OPTIMUS SPORTS TRAINING FACILITY JSP26-08

Consideration at the request of ZAF Investments for approval of Special Land Use, Preliminary Site Plan, Stormwater Management Plan, and Woodland Use Permit. The subject site is located at 43700 W. Twelve Mile Road and consists of approximately 4.34 acres (Section 10). The applicant proposes opening an athletic training center. Indoor recreational facilities are permitted with Special Land Use approval subject to applicable conditions.

REVIEW	RESULT	DATE	COMMENTS
Planning	Approval Recommended	06/24/26	Items to be addressed at Final Site Plan submittal
Engineering	Approval Recommended	04/24/26	Items to be addressed at Final Site Plan submittal
Landscape	Approval Recommended	06/05/26	Landscape waiver under Section 5.5.3.A.v for deficiency in berm requirements on the north and west sides of the site <i>(supported by staff)</i> Landscape waiver under Section 5.5.3.D for location of building foundation landscaping <i>(supported by staff)</i> Landscape waiver under Section 5.5.3.D for deficiency in required percentage of building perimeter landscaping <i>(supported by staff)</i> - Items to be addressed at Final Site Plan submittal
Woodland	Appr

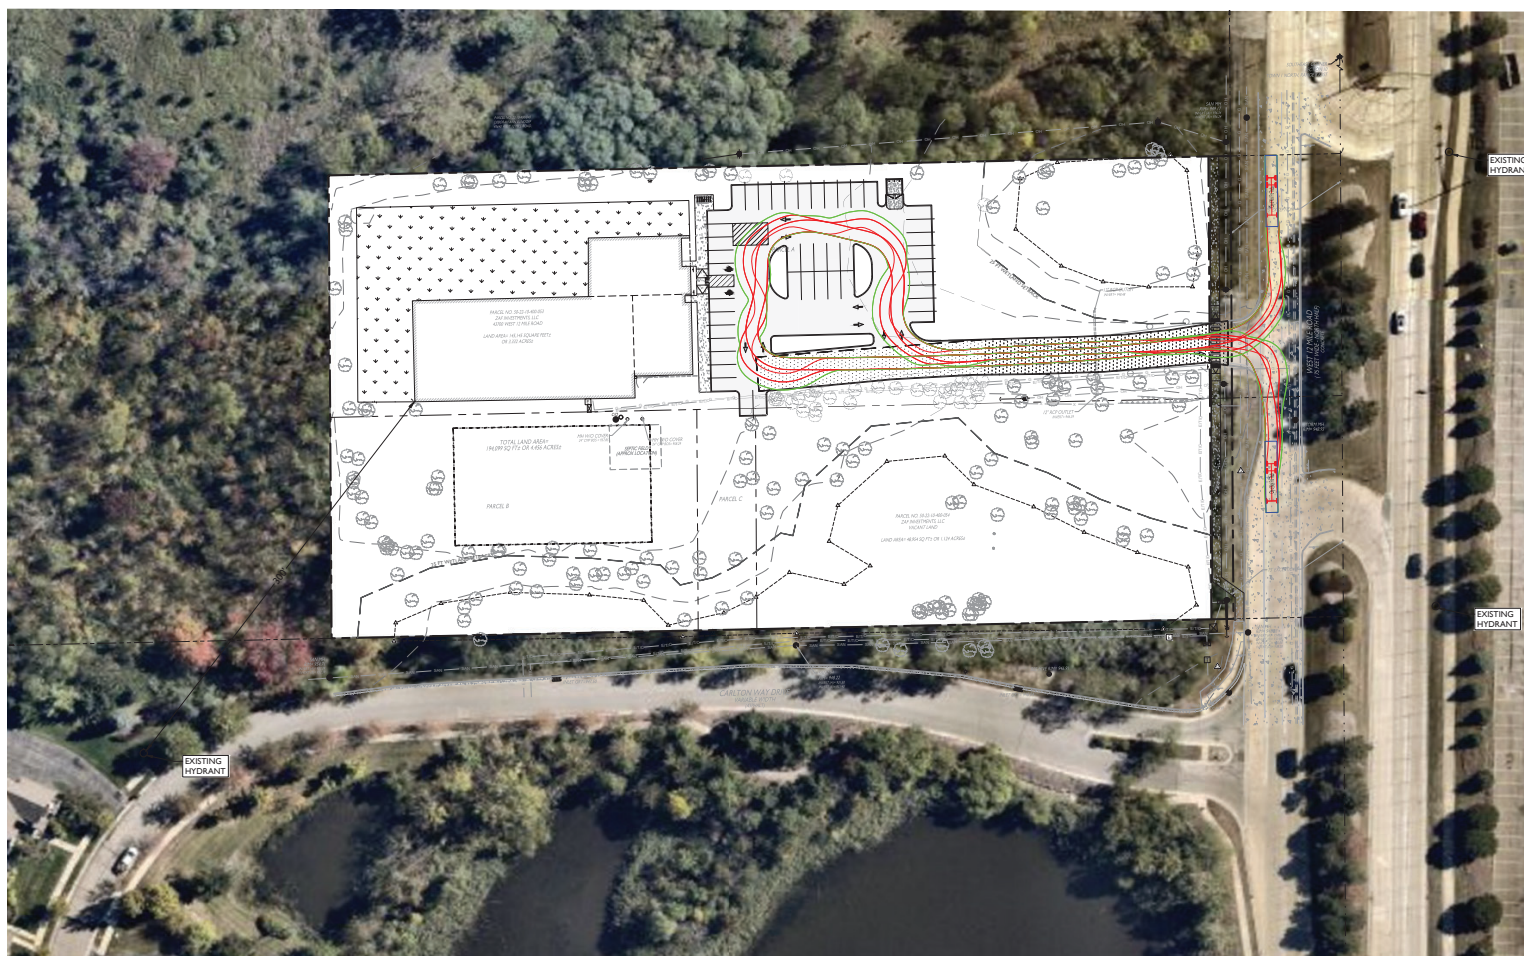
- The minimum width of a posted fire lane is 20 feet. The minimum height of a posted fire lane is 14 feet. **(D.C.S Sec. 158-99(a).)**
- **CORRECTED & APPROVED – from previous reviews on 2/25/26 & 4/12/26** - Fire apparatus access drives to and from buildings through parking lots shall have a minimum fifty (50) feet outside turning radius and designed to support a minimum of thirty-five (35) tons. *(D.C.S. Sec 11-239(b)(5)) This will need to be recalculated on Plan set C-10.0. Plans show fire truck with 40' length. See attached Fire Truck Spec sheet and resubmit for 48' long apparatus with 50' outside turning radii.*

No hydrants proposed, existing hydrants surrounding the site are noted on the Fire Plan, C-10.0.
